Safety-Kleen Tampa H029-158820 (File No. 2)

FILE NAME: Safety Kleen Corporation
PROGRAM : Hazardous Waste

PERMIT #: HO29-158820
COUNTY Hillsborough

SUBJECT: *Safety-Kleen Corporation, FLD 980 847 271*
Operating Permit File No. HO29-158820
Comments on Draft Major Permit Modification

Figure II.B.1-3
 Container Storage Area (South Building)
 Safety-Kleen Corp. Facility
 Tampa, Florida

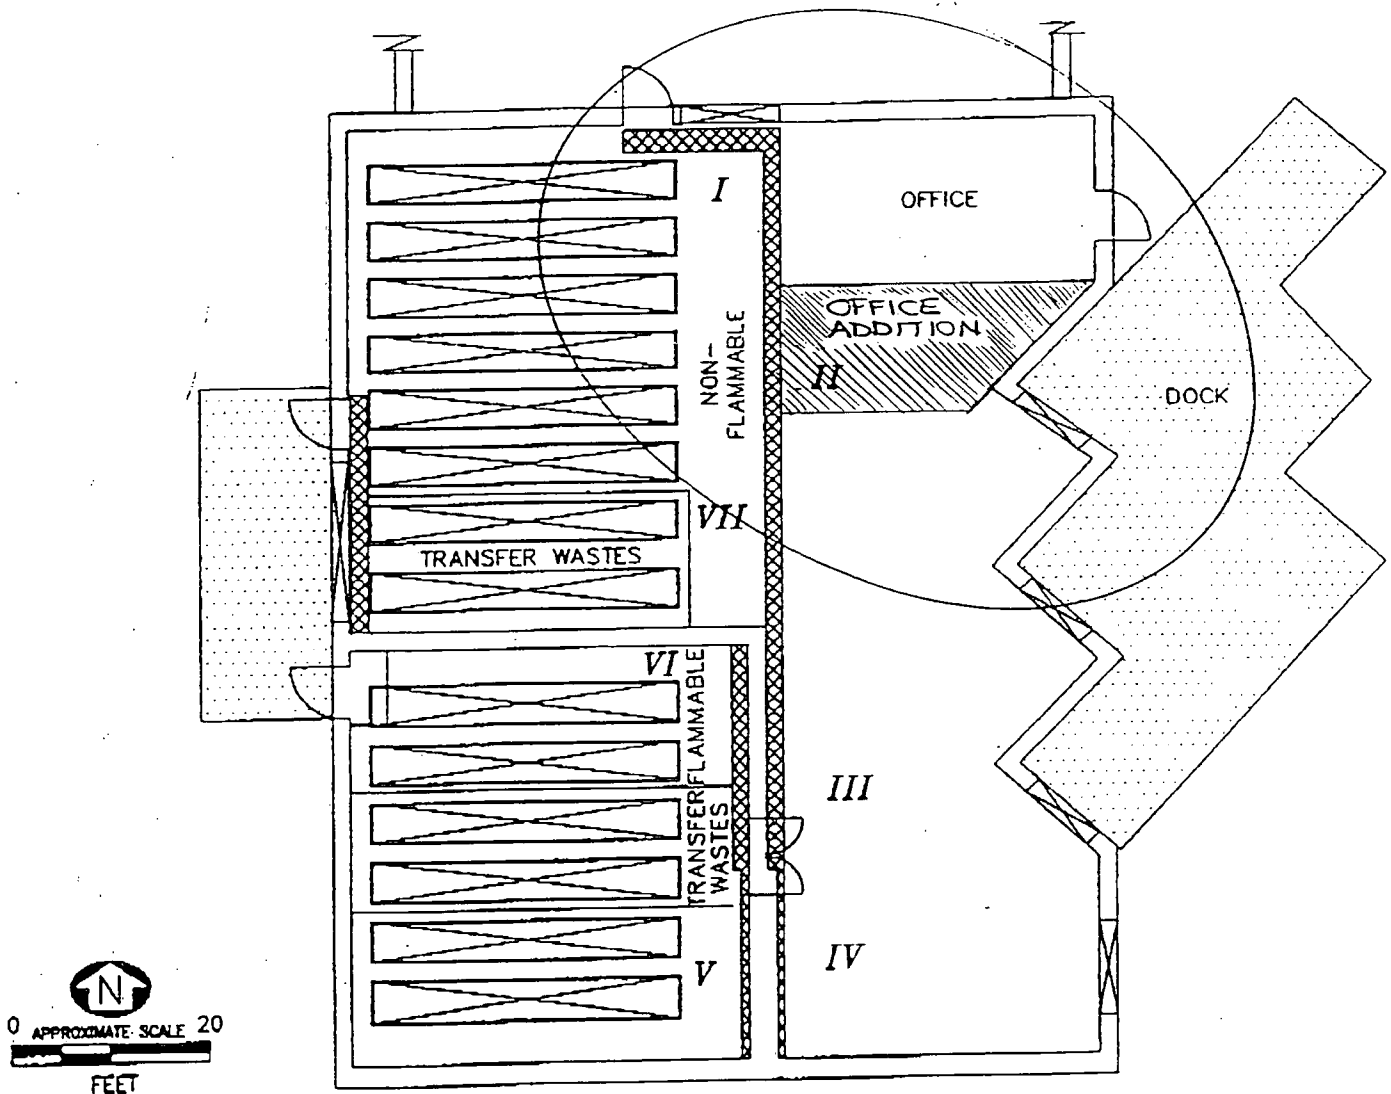
1. One single page cover letter.
2. Two revised Figures (II.B.1-2 and II.B.1-3) to be placed in the active application.

Enclosed are four P.E. sealed copies of Figures II.B.1-2 and II.B.1-3 which have been revised to show the rows where containers will be stored per your verbal request and our subsequent conversation of April 13, 1993.

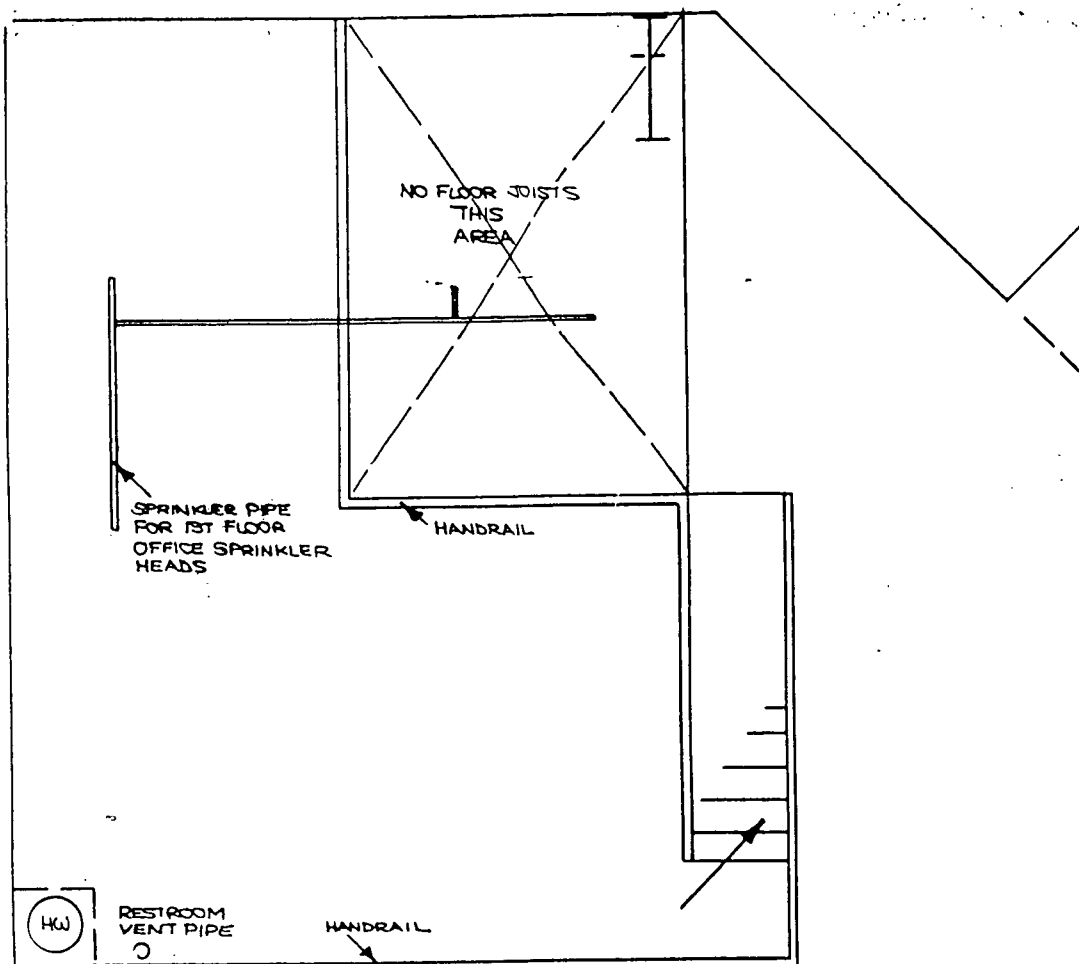
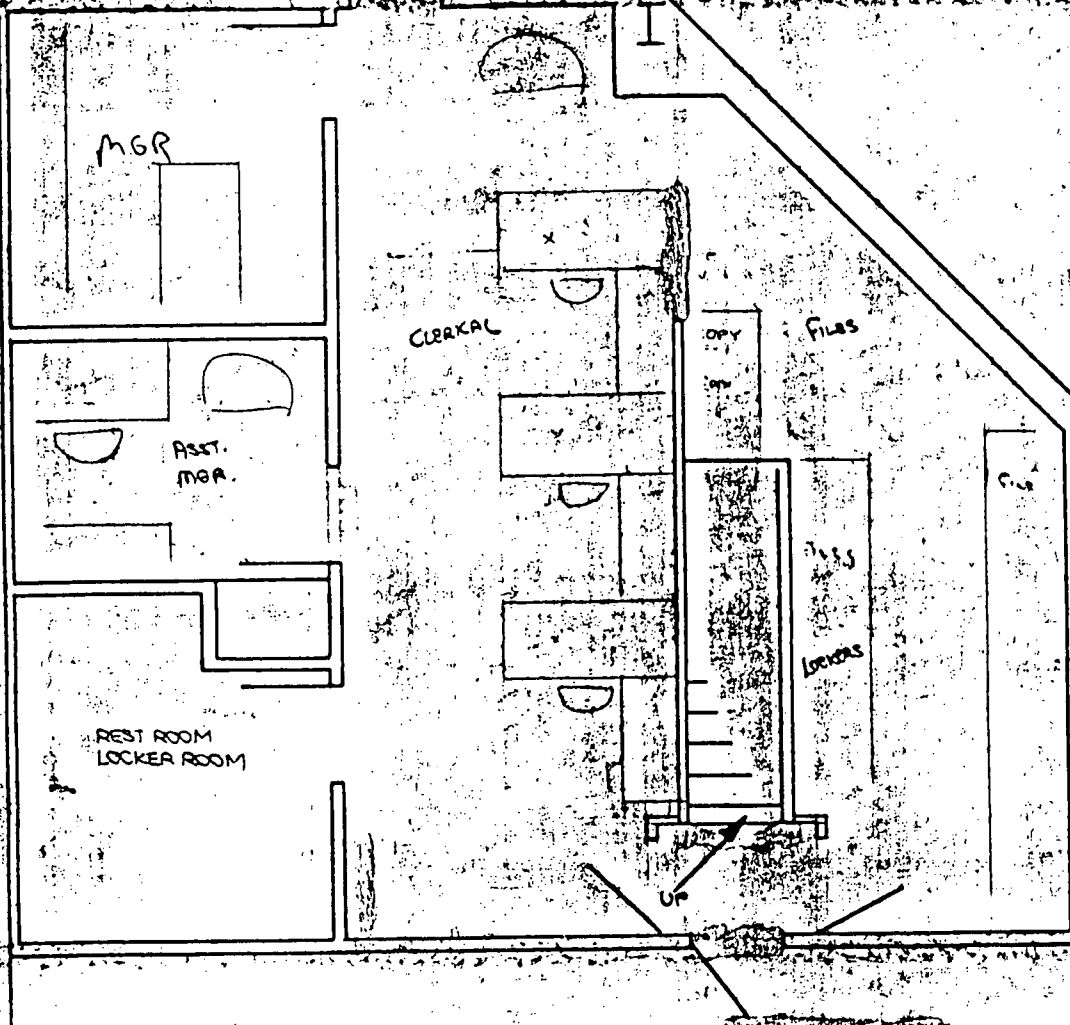
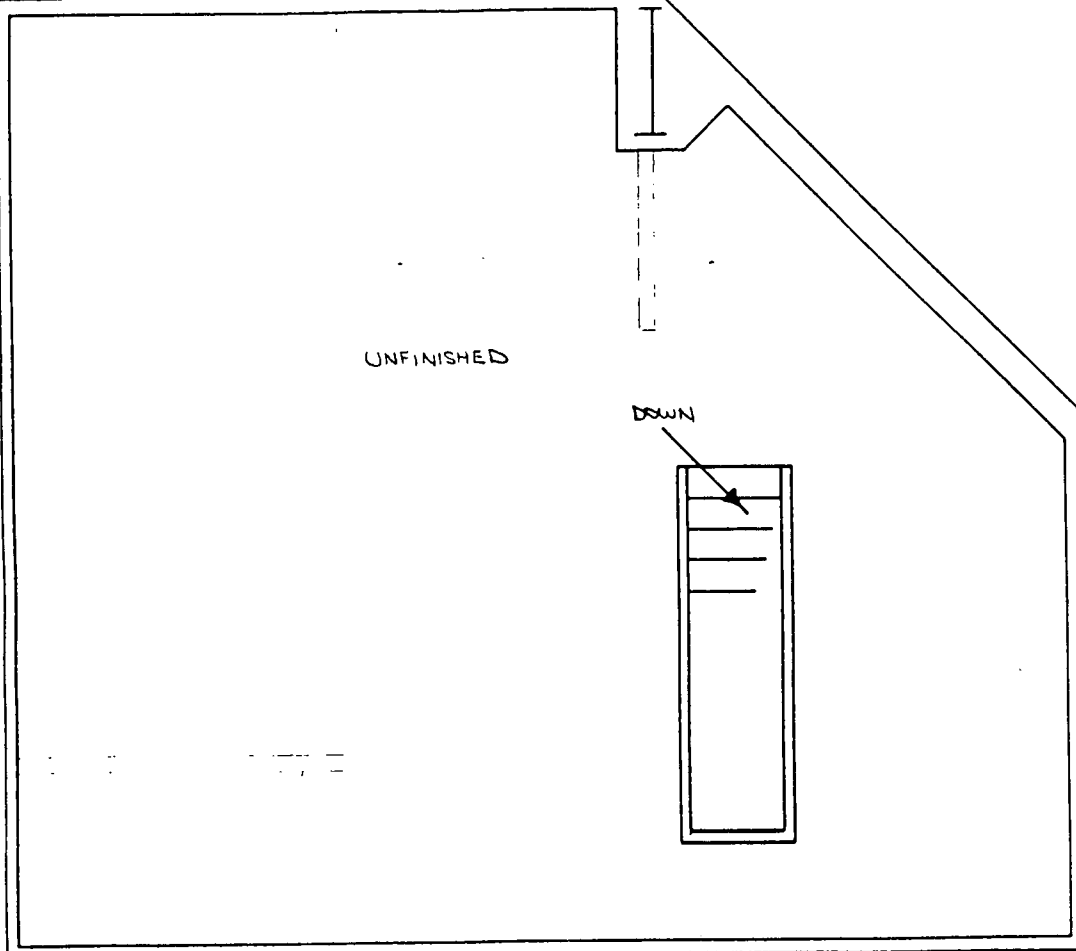
Inclosed are several drawings from the permit application that show the proposed modifications to the accumulation center office area. As these modifications do not alter the hazardous waste storage area (increase or decrease capacity or alter storage arrangements) or restrict the movement of hazardous waste in the storage area, Safety-Kleen understands that this does not constitute a modification of the permit.

Attached are two revised drawings from the TAMPA A/C Part B as well as ~~two~~ several more detailed drawings of the office itself.

The drawings in the permit application that depict the office area in the accumulation area will be revised after the modifications are completed, and these updated pages will be supplied to the FDEP for inclusion in the permit application.
